MeshSat field kit V2, Option A(i) lid pack: sheet A1-1 arrangement B in plan: the lid module, the QMX set and every face part under the lid

MESHsat-1357, stream a1mech, 29 Sep 2026. Case frame: X east, Y toward the hinge (back) wall, Z up from the base floor, lid closed. mm. Prototype design, AI review: nothing built, bought or fitted; analytical success is not physical verification.

MeshSat field kit V2, Option A(i) lid pack: sheet A1-3 the arrangements that fit, and the owner decision

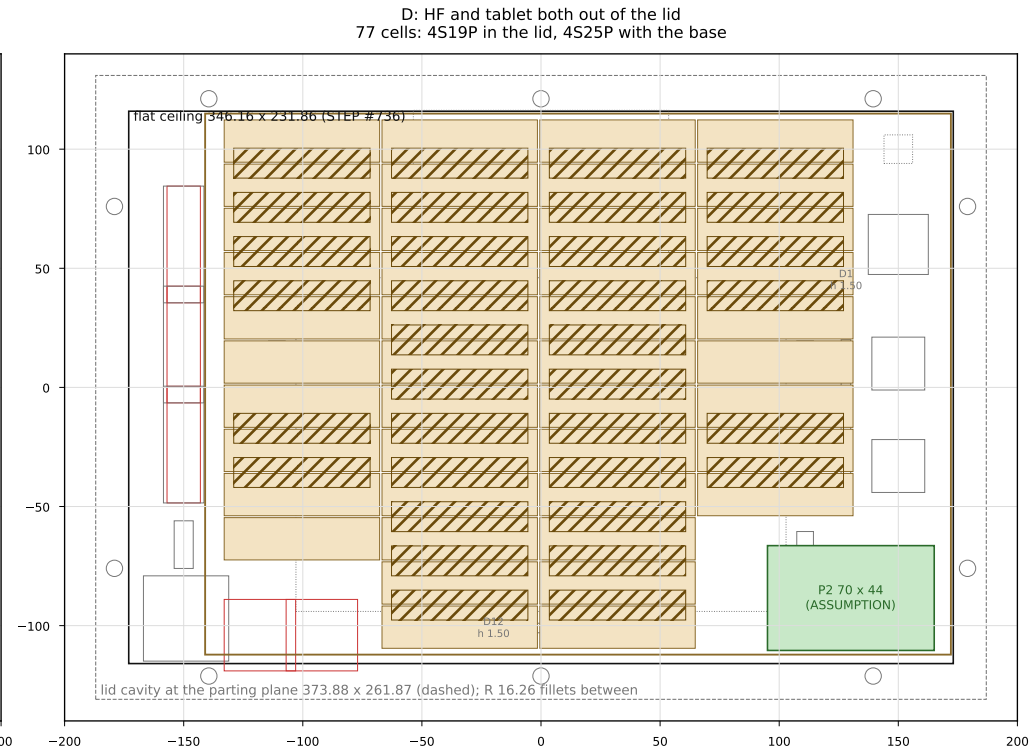
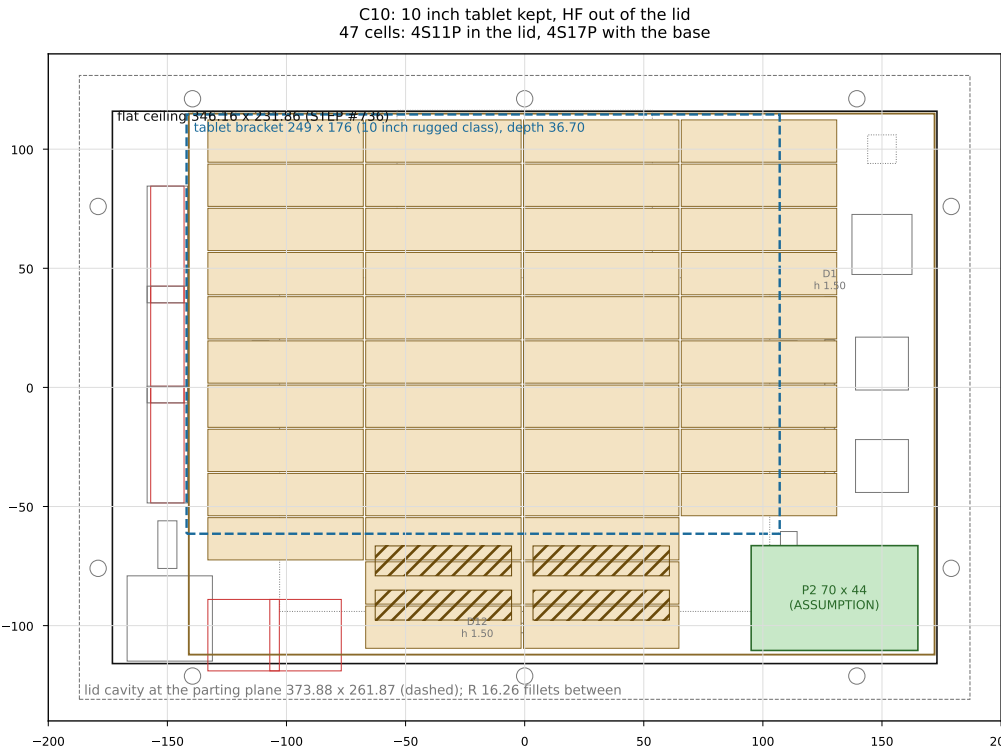
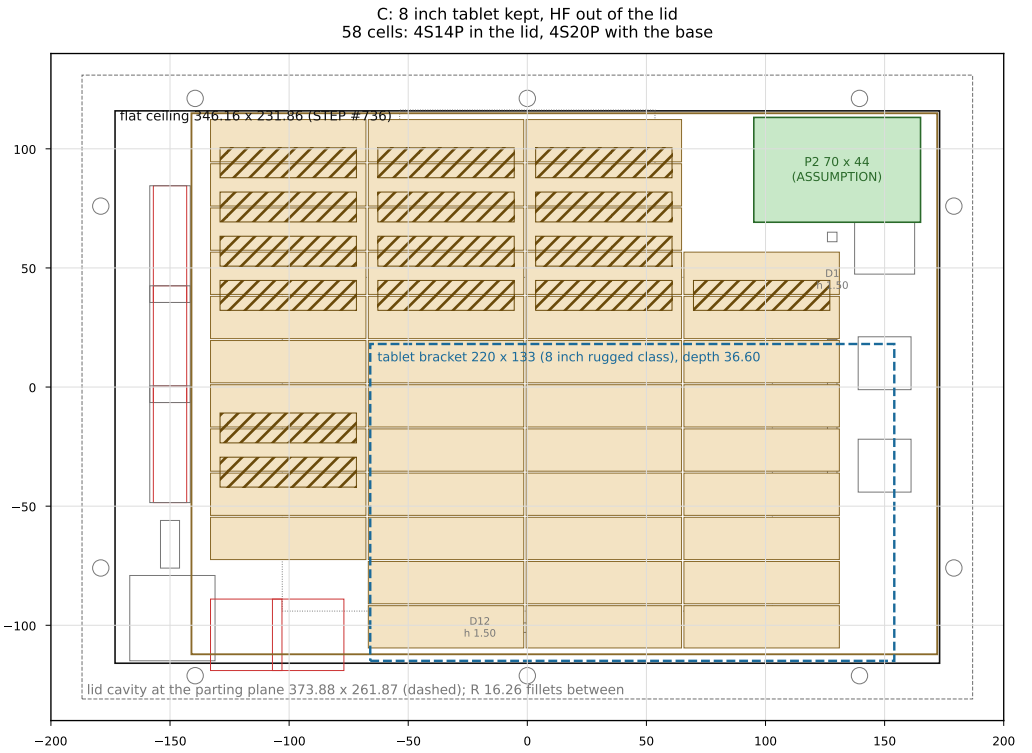
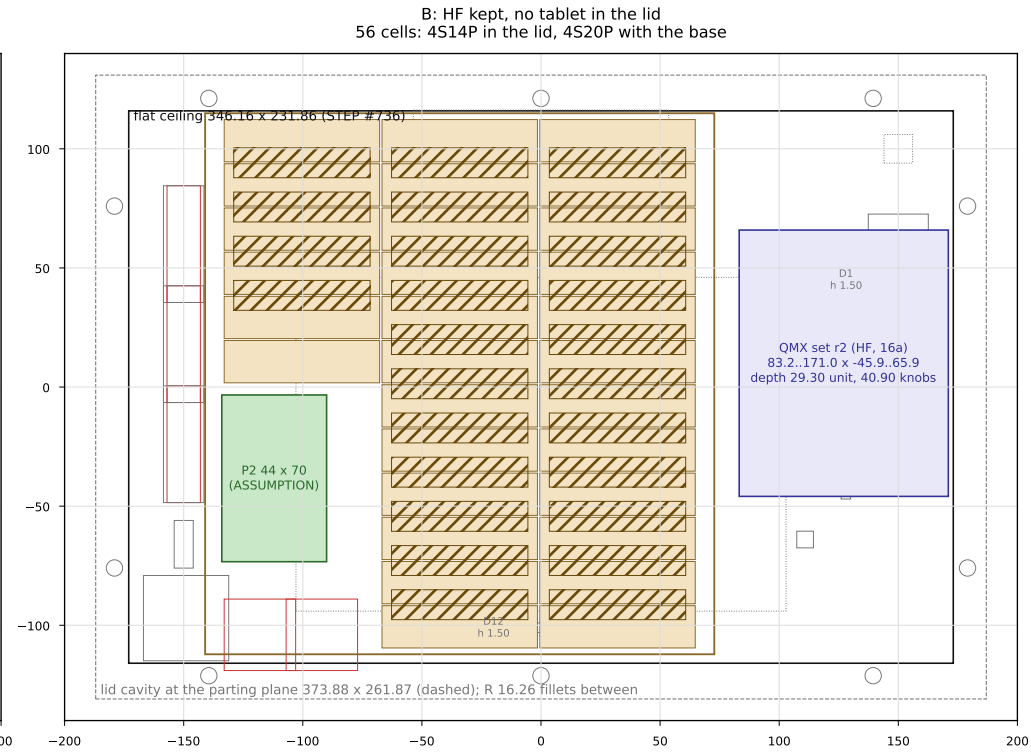
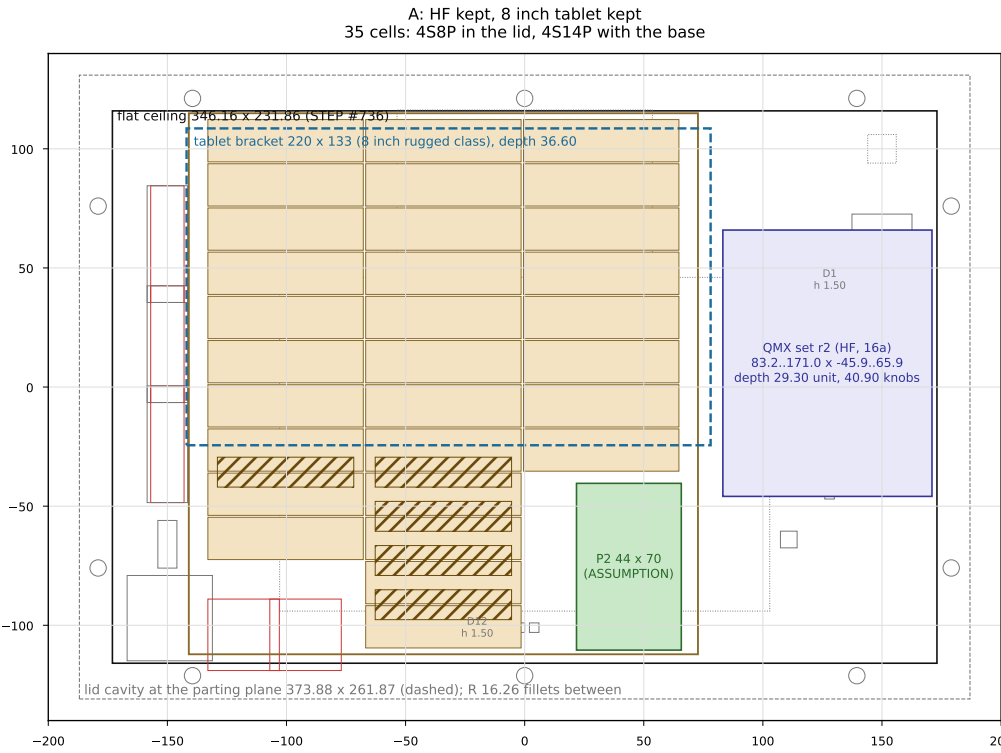
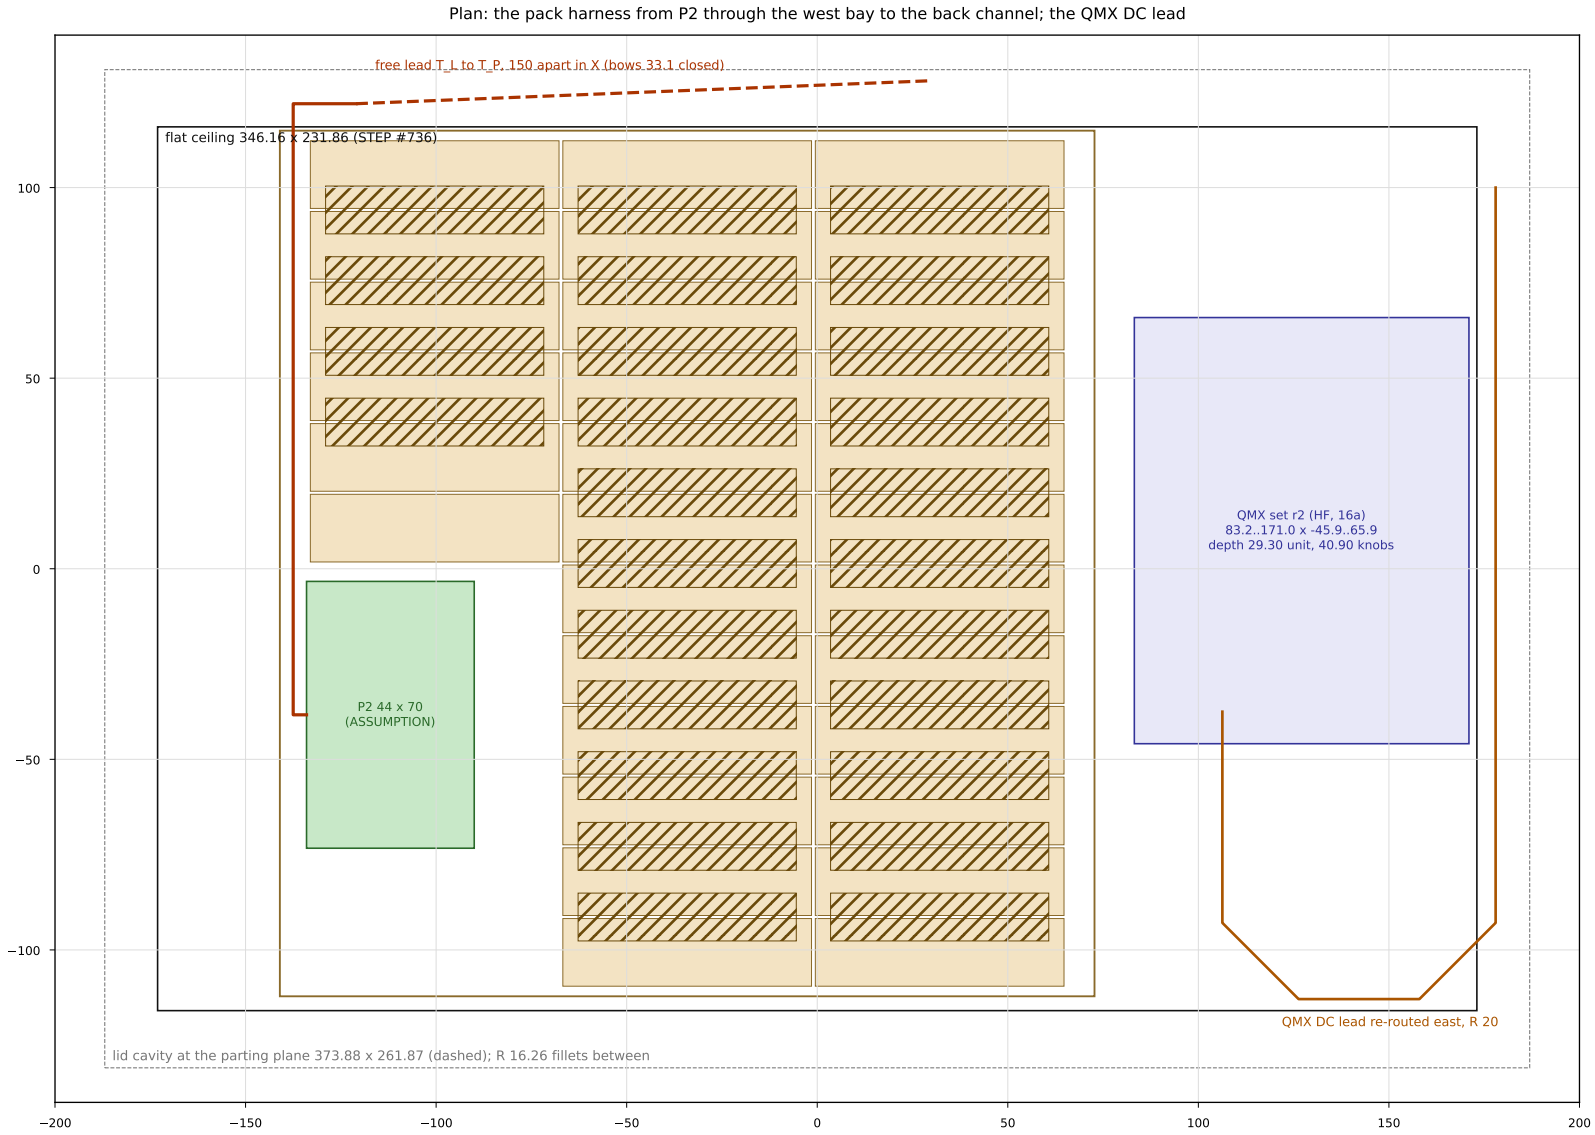
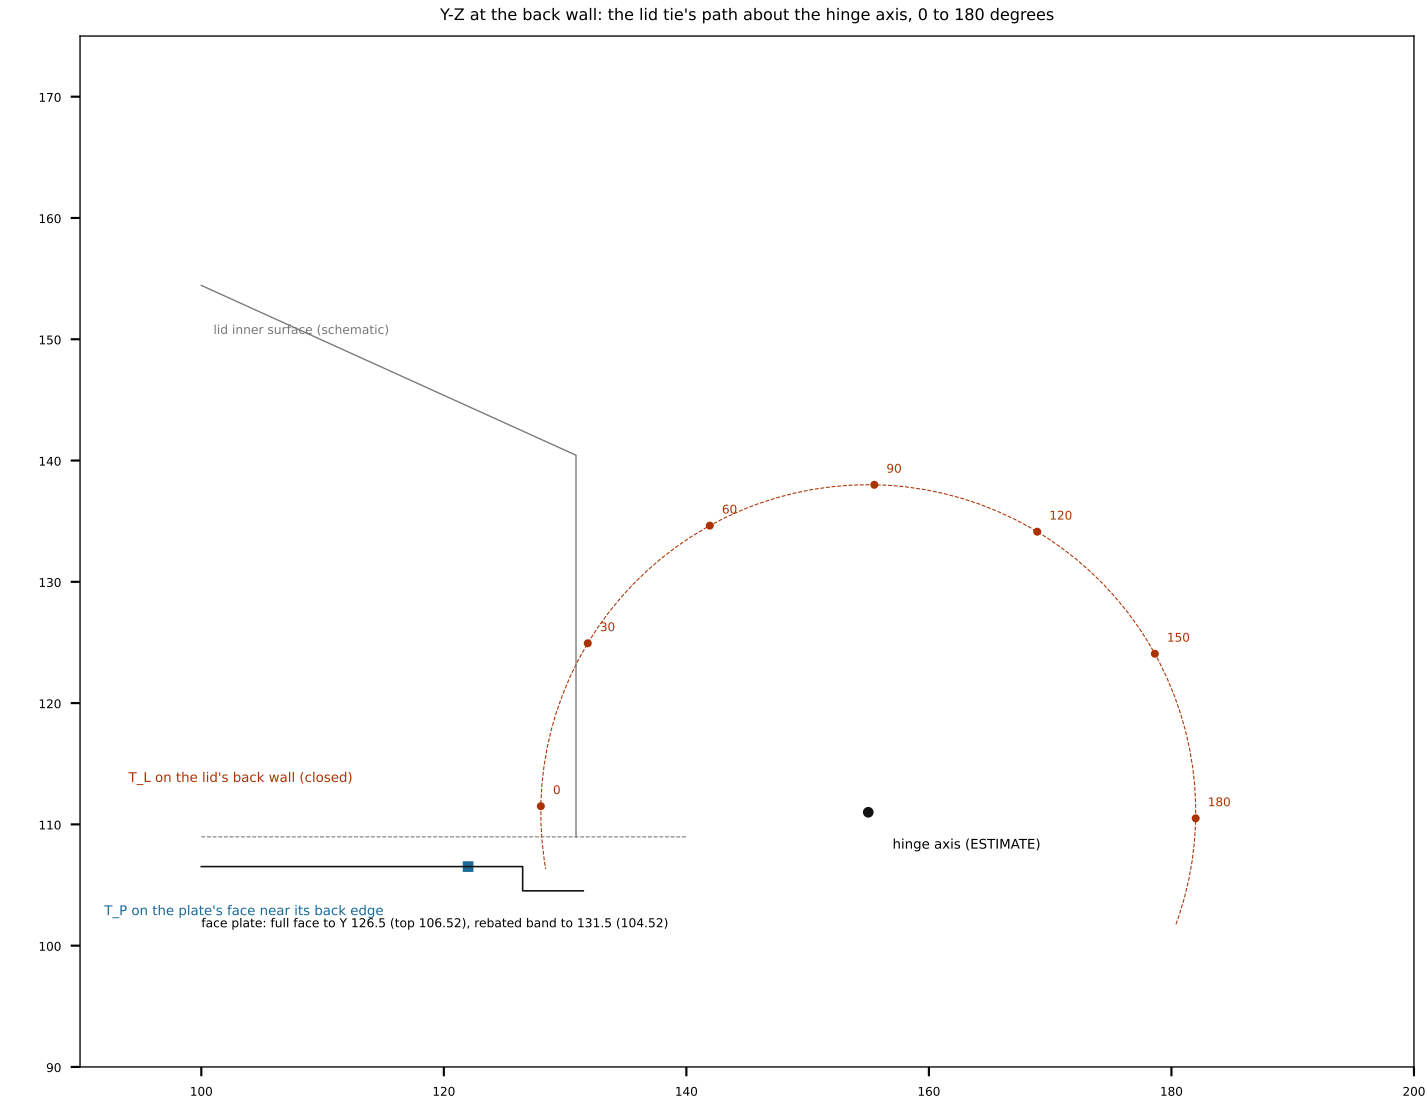
48 cells (4S12P) in the lid with BOTH the QMX HF set (16a) and the tablet bracket (16d): DOES NOT FIT.
At the worst room the lid holds 35 places with both, 4S8P; the total 4S14P is under section 9c's 4S15P floor.

What fits 4S12P (each with every row of sheet A1-1 at or above its minimum at the worst):
1. HF kept, tablet bracket out of the lid:
56 places (4S14P); the tablet goes out of the case.
2. 8 inch tablet kept, HF (QMX) out of the lid:
58 places (4S14P); HF inside (16a) is lost: the base has no volume for the QMX set (section 8)
3. Both kept, lid pack 4S8P: not Option A(i); M1 not met on section 9's model

10 inch tablet: fits only with HF out: 47 places (4S11P).
Both out: 77 places (4S19P).

Session's recommendation (engineering view only):
option 1, which keeps a radio bearer and gives 8 spare places; the tablet works from outside the case on the kit's WiFi and USB-C outlet.

D-01 already defers HF, the tablet bracket and a second pack from prototype 1: Option A(i) reopens D-01 whichever option is taken.

MeshSat field kit V2, Option A(i) lid pack: sheet A1-5 mass and open-lid stability

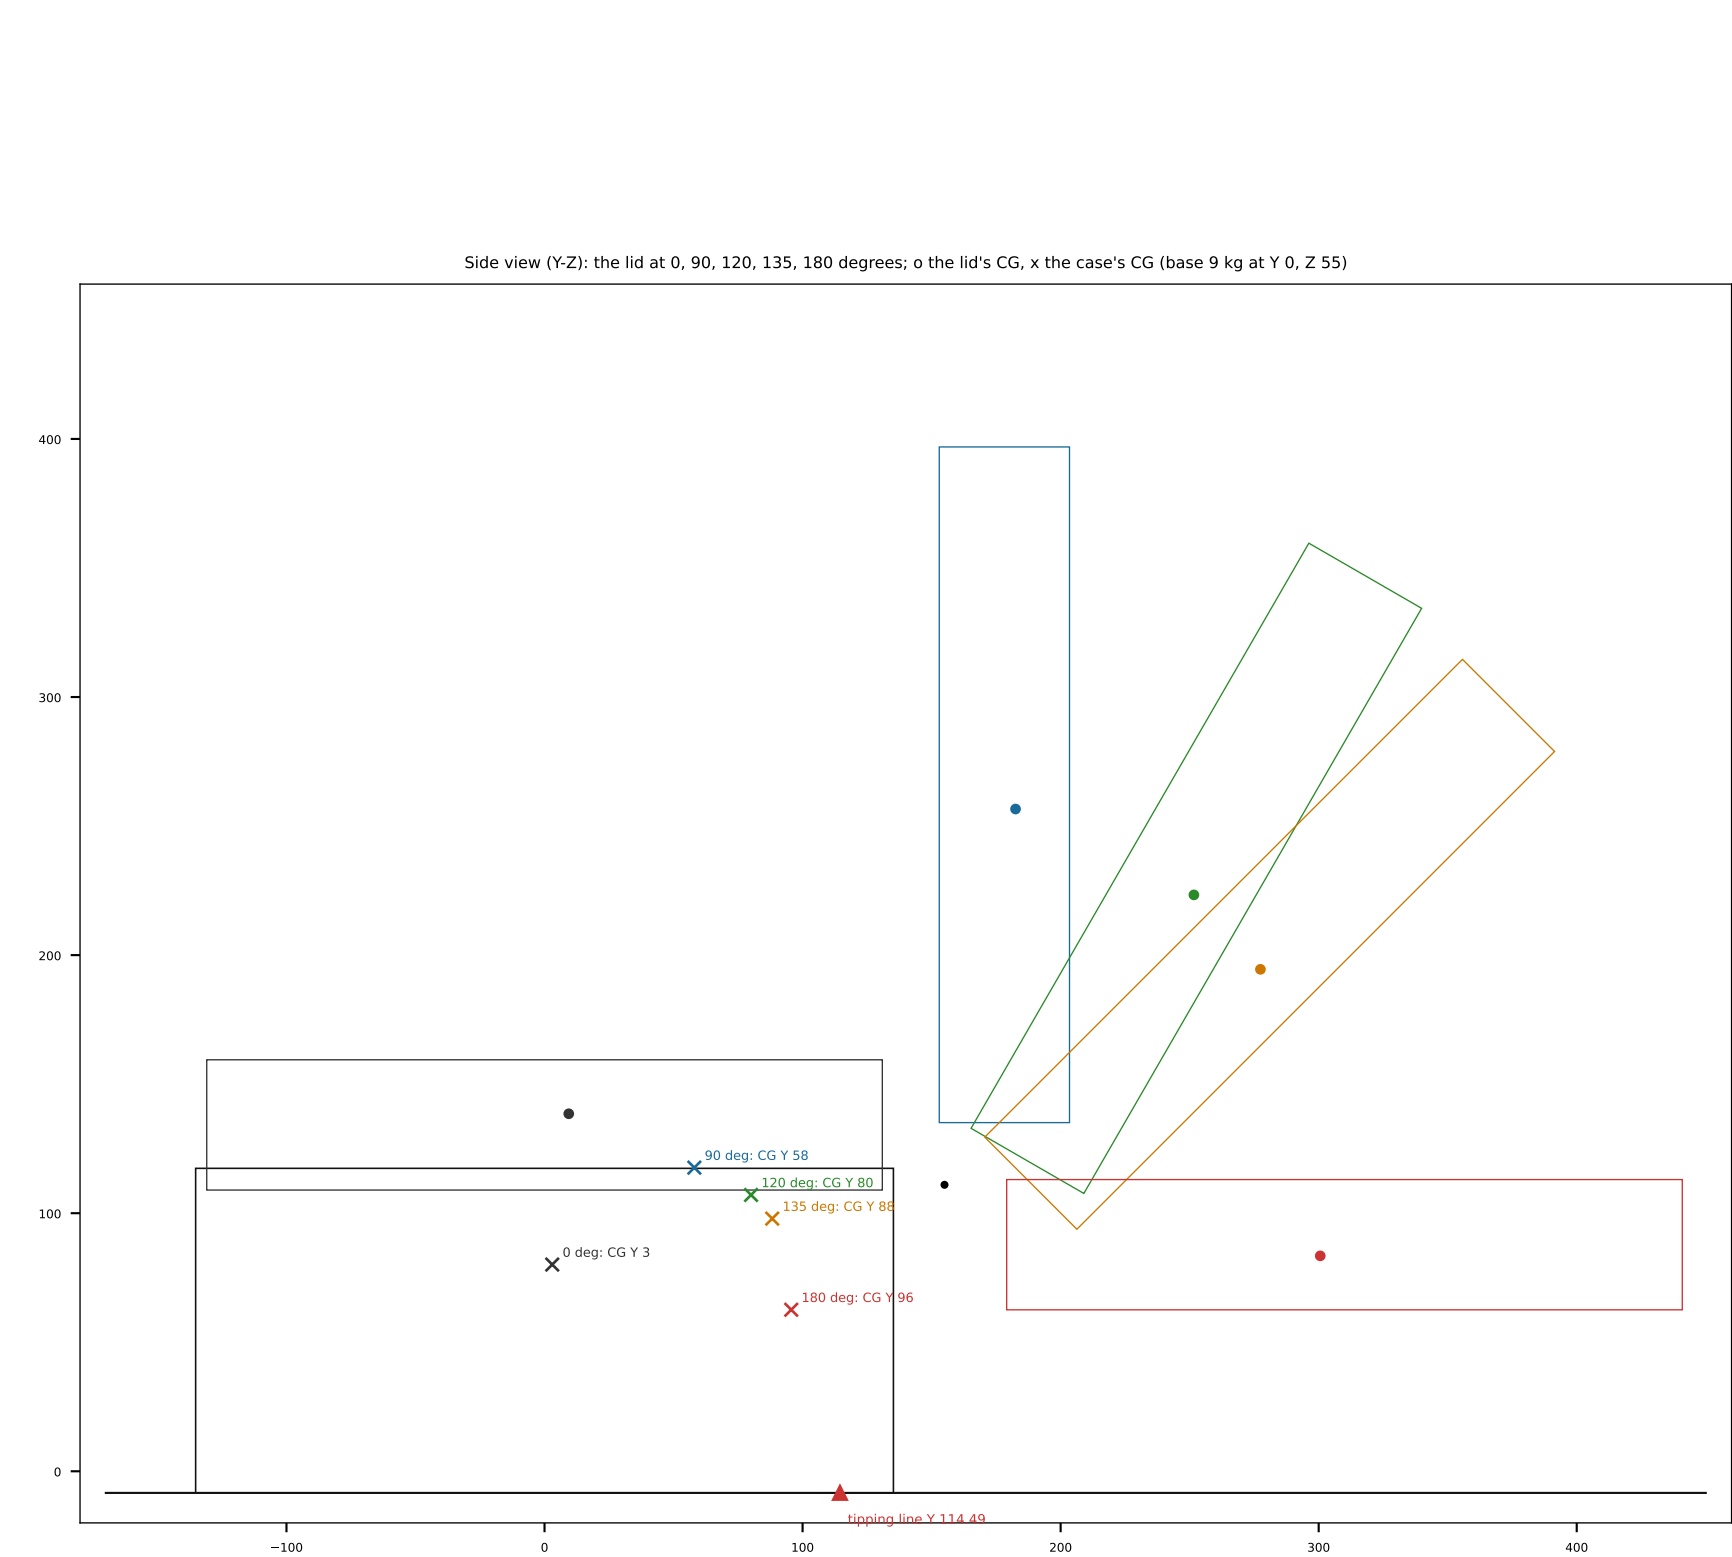
WORST OVER THE SWEEP (base 7..14 kg, CG Y -20..+20, Z 45..65, hinge axis Y 147..163): critical back slope, deg

lid open	B	A
90	14.9	17.1
100	11.6	14.0
110	8.4	11.1
120	5.4	8.4
135	1.3	4.9
150	-2.2	2.2 (tips on level ground)
180	-5.0	1.7 (tips on level ground)

VERDICT: stands on level ground to 120 degrees of opening in every swept case; a light base tips from 135. FIX (SESSION, reversible): a lid stay stopping the lid at 100 degrees (webbing strap between two bonded anchors, lid back wall and plate back band; no hole; about EUR 10, ESTIMATE). With it the open case stands on a slope of about 10 degrees at the worst (lid_pack_a1.out section 4). The stop angle, the hinge axis and the case's CG are read on the mock-up (T-A1-3); Peli states no load for its hinges (T-A1-4).
